PLANNING APPLICATION CONSULTATION RESPONSE

Memorandum to: (Case Officer)	Jonathan Ryan, Principal Planning Officer
From:	Heather Cameron, Public Open Space Officer
Email:	heather.cameron@southglos.gov.uk
Date:	22/04/22
Planning Application Number:	P22/01300/O
Site Address:	Land At Sodbury Road, Wickwar, South Gloucestershire, GL12 8PG
Description of Development:	Erection of up to 180 dwellings, a local shop and associated infrastructure (Outline) with access to be determined; all other matters reserved
SUMMARY OF POS SECTION 106 REQUESTS	
Off-site POS provision/ enhancement contribution	TBC see table below
Off-site POS maintenance contribution	TBC see table below
On-site POS	TBC
POS inspection fees if private management proposed	£63.96 per 100sq.m.plus £615.90 core service fee

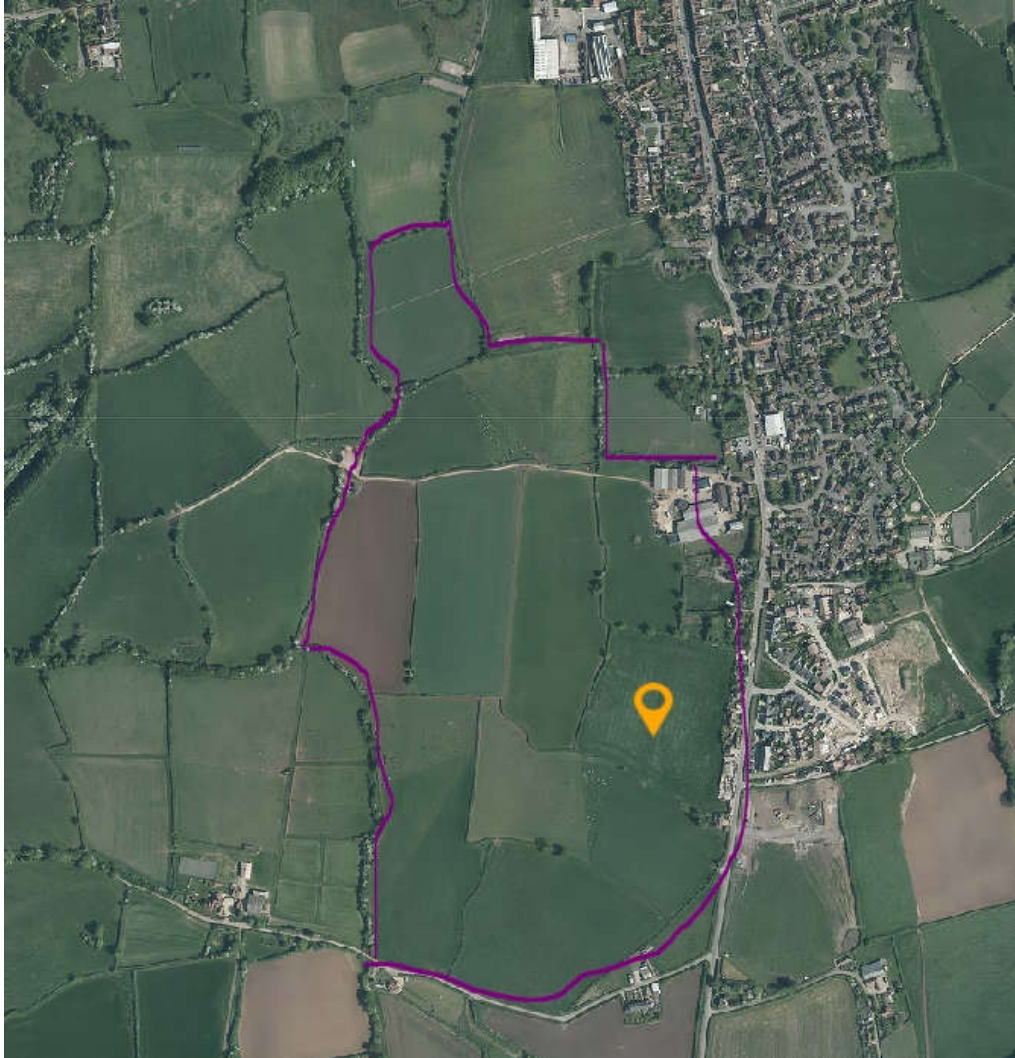
Outdoor Sports Facilities - None are proposed and no justification as to why off-site provision creates a more acceptable proposal than on-site. It is clear from the application documentation that although the current application is for 7.89ha, the applicant intends to apply for permission on 38ha in total. The current application is therefore only 20% of that land. I consider that they should be providing entirely for their own needs within this application or within their land. I consider it unreasonable for them to abdicate their responsibility to deliver to cater for the needs of their residents and to expect the Council/Parish Council to deliver on their behalf, as there is probably a limit to what can be delivered/improved at local facilities. If permission were to be granted for the outline application, I feel it should be on the basis of four options.

I am not sure how feasible this is, and I know we can only look at the current outline application but the documentation is clear:

The wider development area covers approximately 38ha of greenfield land on the periphery of south-west Wickwar, located by National Grid Reference of ST 72334 87387 and nearest postcode of GL12 8PB. Refer to Phase 1 red-line boundary in Figure 1.

Topo plan covers roughly this extent of land:

1. A combination of on-site provision of something like a MUGA plus the balance on the remainder of the 38ha
2. A combination of on-site provision of something like a MUGA plus the balance by way of off-site contribution
3. An off-site contribution
4. If further development is approved, the entirety of the requirement should be delivered within the Bloor land.

Figure 26: Illustrative Cross Section of Attenuation Features within Open Space

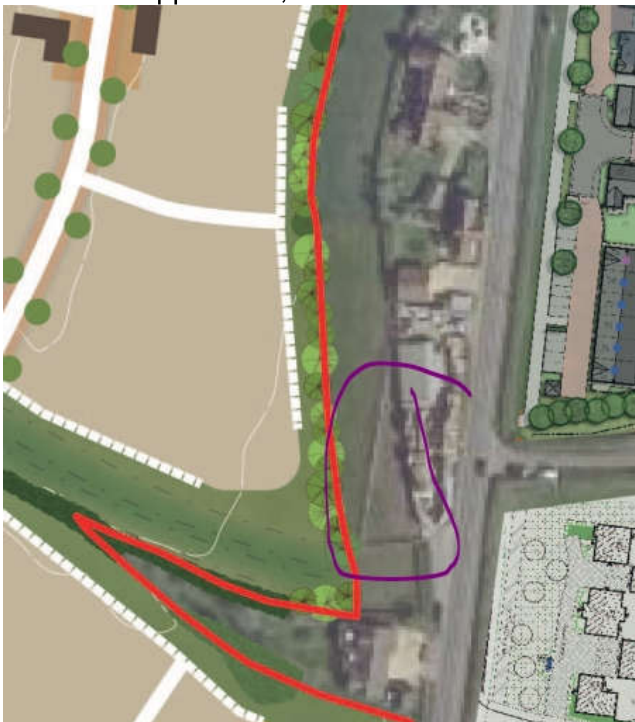
The illustrative cross-section of the attenuation basin in the DAS does not seem to match the scale of the basin in the drainage strategy where little usable space is left around the perimeter:

Our experience is that illustrative proposals are always almost over-optimistic, and that detailed designs require a greater land take in order to attenuate the volume required; consequently usable POS becomes reduced.
